# Access Compliance Report

## Public Rights-of-Way

Intersection ID: 2940	Main Street: DOWNFIELD_WOOD_DR	Cross Street: HARBURN_FOREST_DR	Location: NW
ADA ID: 437C7218D8AC	Ramp Type: BlendTrans1	Initial Pass/Fail: Pass	Overall Compliance: No
Severity Score: 10			
Codes/Mitigation Info/Possible Solution		Field Measurements/Component Compliance

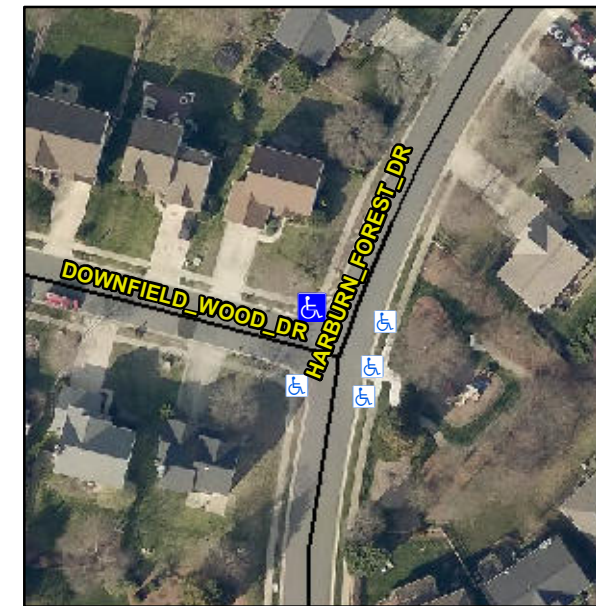
**Not Found, R304.2.1, R304.2.2-Perp, R304.3.2-Para, R305**

**Remove & Replace Curb Ramp With Two New Directional Ramps or Equivalent.**
